The Sizewell C Project

Consultation Document

Consultation on Further Proposed Project Changes

Figure 4.5: Proposed amendments to the limits of deviation (B1122/25 link, Trust Farm Link and Hawthorn Road)

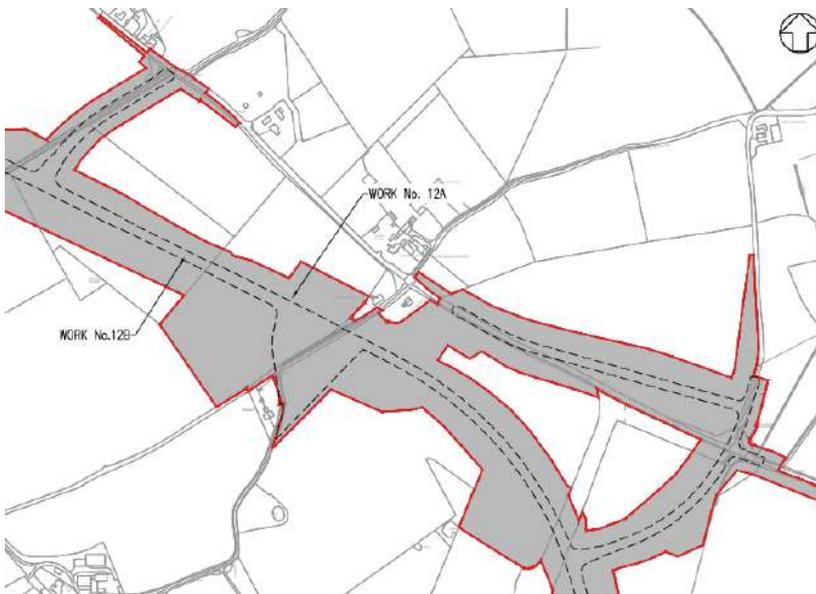
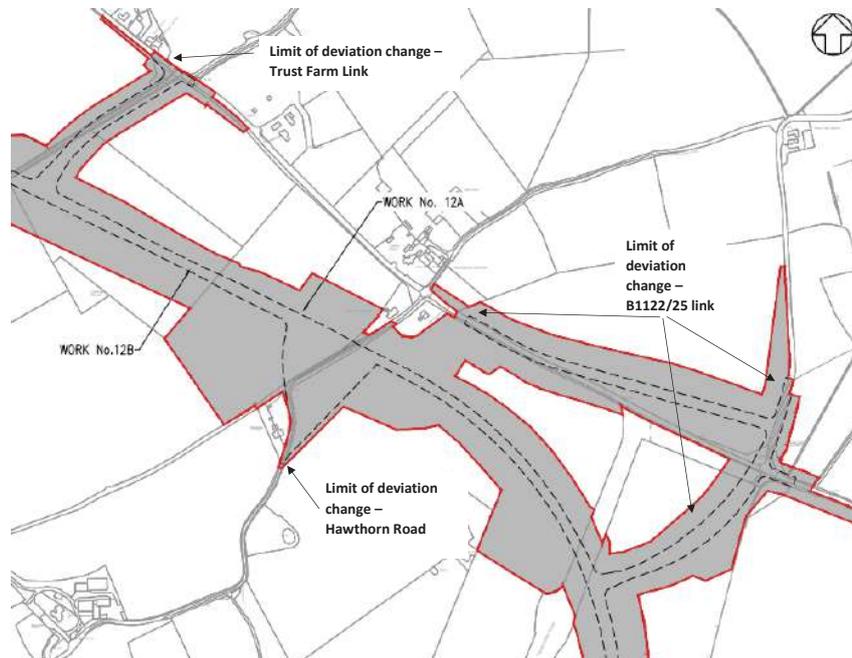
4.2.12. SZC Co. proposes to change the road layout and increase the carriageway level at the B1122/25 link. This change is as a result of progressing the design of the Sizewell link road through detailed engagement with SCC and would avoid the need to depart from the DMRB standards.

4.2.13. This change would result in an amendment to the dashed limit of deviation line shown on Works Plan SZC-SZ0204-XX-000-DRW-100255 Rev 03 [Examination Library Ref. [AS-286](#)], to allow a slightly revised road layout as indicated in **Figure 4.5**.

- Trust Farm Link/B1122 junction (refer to **Figure 4.5**);
- Moat Road junction (refer to **Figure 4.4**); and
- Eastern end of the Sizewell link road where it joins the existing B1122 (refer to **Figure 4.4**).

Figure 4.6: Proposed amendments to the levels of the B1122/25 link

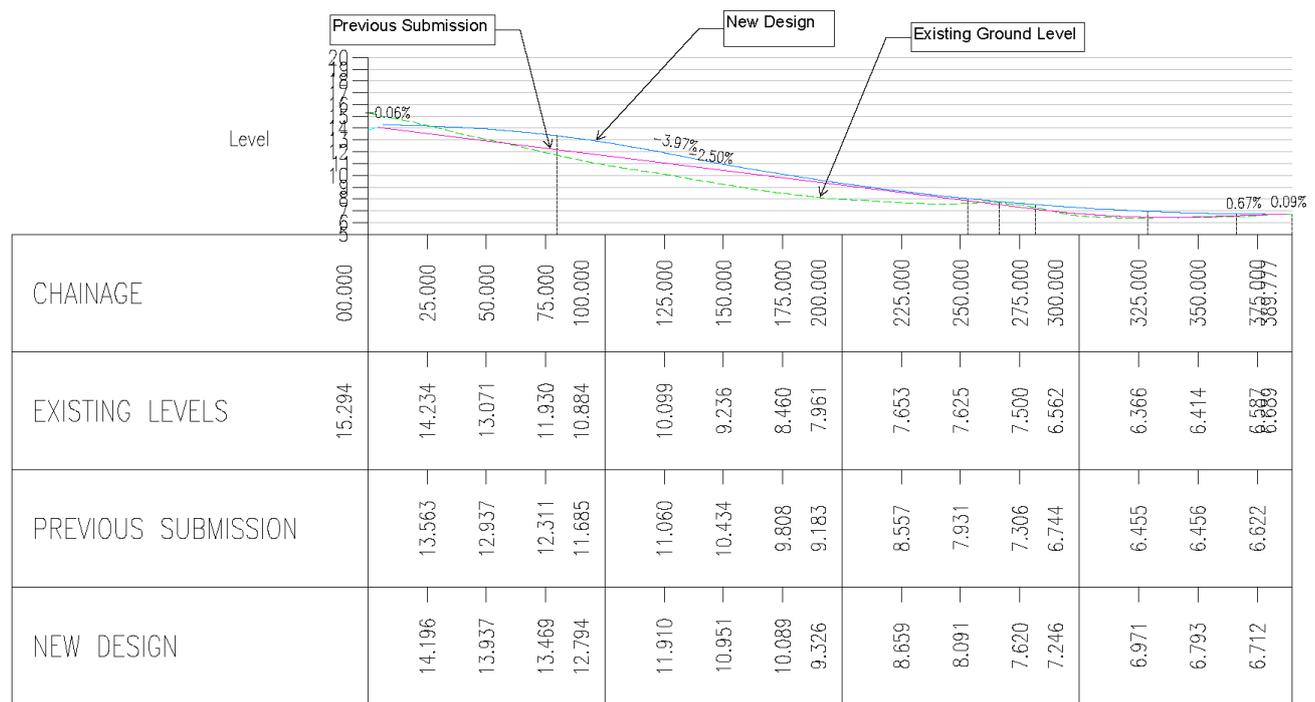
4.2.14. From the junction of the B1125 link with the proposed Sizewell link road, the road profile levels are increased by a maximum of 1200mm above the previous profile at chainage 75 (as shown on General Arrangement plan SZC-SZ0204-XX-000-DRW-100066 Rev 02 [Examination Library Ref. [AS-137](#)]) and then continue to decrease towards

chainage 210 where level change is less than 100mm. The levels then increase up to 500mm at chainage 300 and then decrease to chainage 389 where the profile ties into the existing road profile levels. The changes are minor and are best understood by reference to **Figure 4.6**

4.2.15. The levels are proposed to be raised to allow proposed drainage pipework to pass under the new road profile from the attenuation basin to the existing watercourse.

Figure 4.7: Proposed amendments to the Order limits (Hawthorn Road and B1122/25 link)

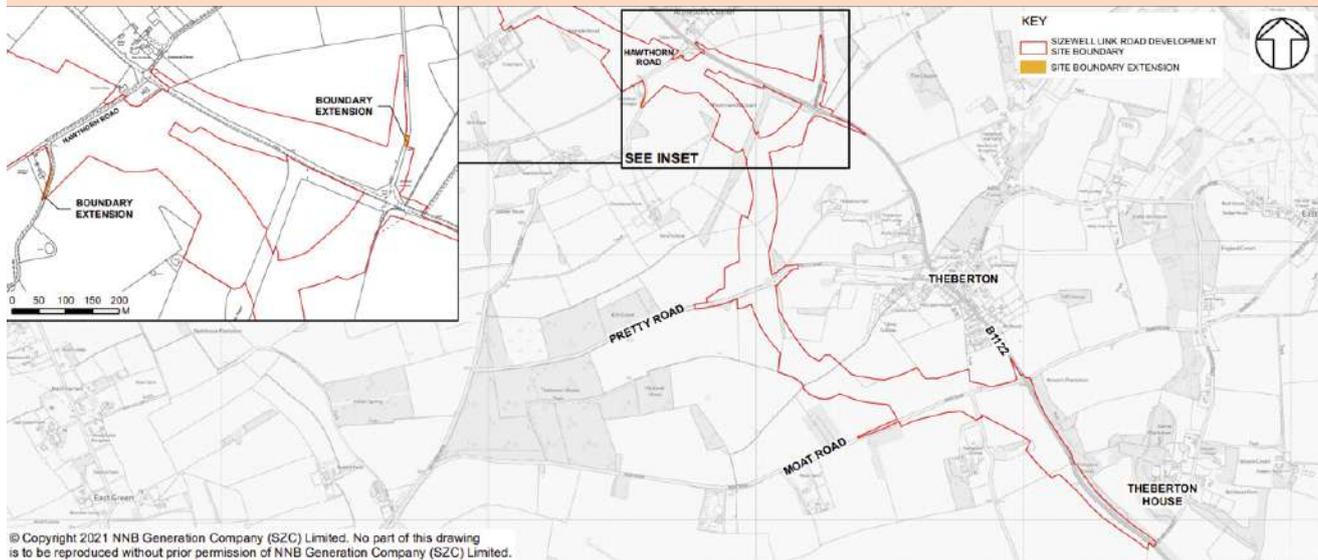
4.2.17. This change would require a small increase in the Order limits to allow for the link to tie into the existing B1122 appropriately, as indicated in **Figure 4.7**. However, this extension would involve highway land only over which no compulsory acquisition powers would be required. The change is understood to be supported by SCC.

4.2.18. A small increase to the Order limits in this location is proposed, as indicated in **Figure 4.7**. This would allow for an improved tie in between the proposed Sizewell link road and the existing Hawthorn Road. This extension would involve highway land only over which no compulsory acquisition powers would be required. The change is understood to be supported by SCC.

Figure 4.8: Proposed amendments to the limits of deviation (Middleton Moor roundabout)

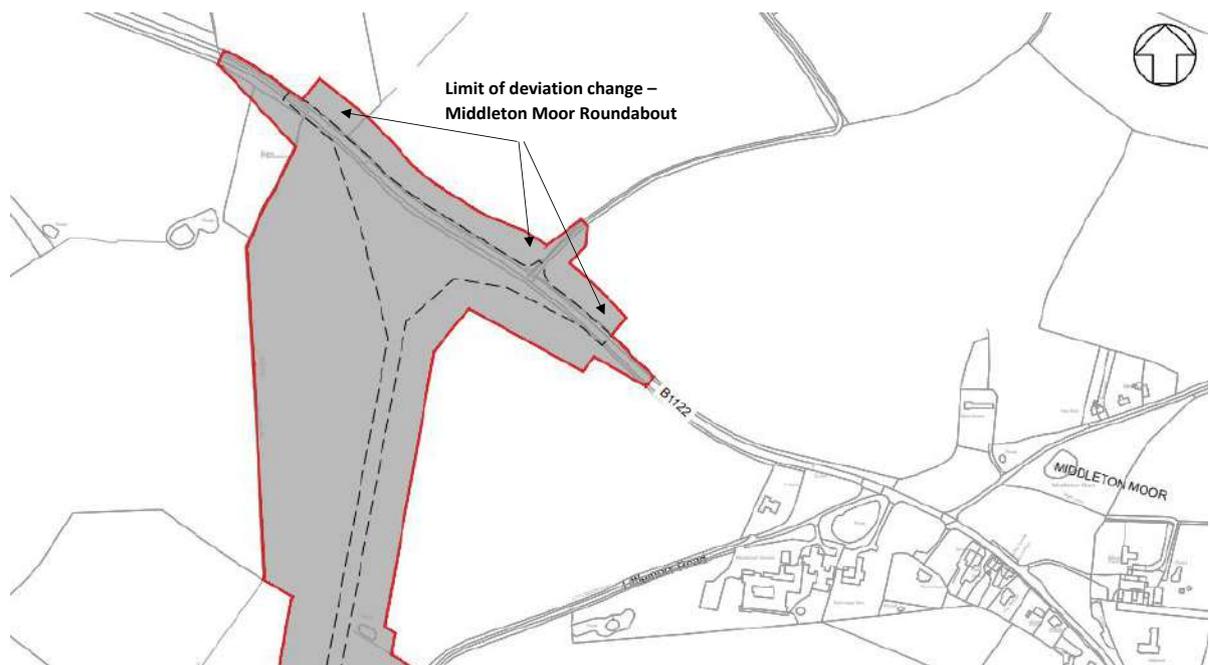
4.2.21. It is also proposed to make minor revisions to the limits of deviation as shown on Works Plan SZC-SZ0204-XX-000-DRW-100254 Rev 03 [Examination Library Ref. [AS-286](#)] at the Middleton Moor roundabout to allow for improved tie ins with the existing highway (refer to **Figure 4.8**). Further site investigations, including topographical survey, have shown this to be required.

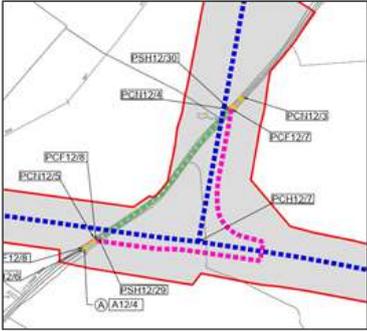
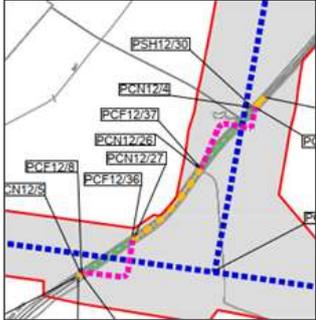
E-344/013/0	19 (SZC-SZ0204-XX-000-DRW-100338 Rev 02)	During operation, Footpaths E-344/013/0 and E584/016/A (which connect together where they cross the site to form one route) would be realigned to cross the proposed route of the Sizewell link road approximately 70m west of their existing location. 	During operation, Footpaths E-344/013/0 and E584/016/A (which connect together where they cross the site to form one route) would be realigned to cross the proposed route of the Sizewell link road approximately 80m west of their existing location, up the road embankment at a shallow gradient. 
E-584/016/0	20 (SZC-SZ0204-XX-000-DRW-100339 Rev 03)	Users of footpath E-584/016/0 travelling from southeast to northwest would be permanently diverted north and west to cross the proposed Sizewell link road. 	Users of footpath E-584/016/0 travelling from southeast to northwest would be permanently diverted north and west to cross the proposed Sizewell link road. The alignment of the proposed diversion route has been revised slightly to enable a perpendicular crossing of the proposed Sizewell link road, and this has also shortened the length of the proposed diversion route by approximately 6m.

E-396/023/0

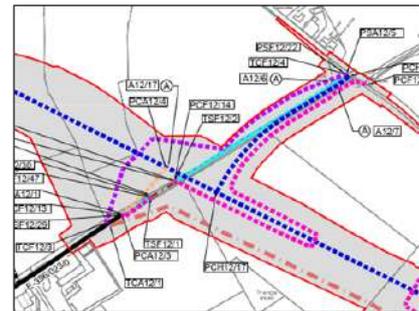
Upon completion of construction, users of footpath E-396/023/0 would be diverted to the east of its existing alignment. On the south side of the route of the proposed Sizewell link road, footpath would run alongside the route of the proposed Sizewell link road E-396/023/0 and would be diverted to the east by approximately 200m to cross the road, approximately 150m to the east of the ghost island junction. On the north side of the proposed Sizewell link road route, the footpath would then be diverted west towards the ghost island junction and then directed north-east along the proposed access road to join the B1122.

This change has been proposed in order to provide greater spacing between the crossing and the ghost island junction.

Extension of Footpath E-396/020/0

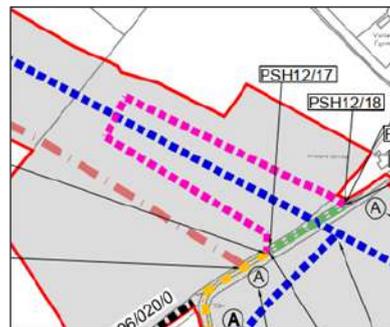
An extension of Footpath E-396/020/0 from the existing Hawthorn Road. The footpath would extend along the proposed route of the Sizewell link road, approximately 160m to the west, to cross the proposed route before heading west east along the north side of the route to re-join Hawthorn Road.
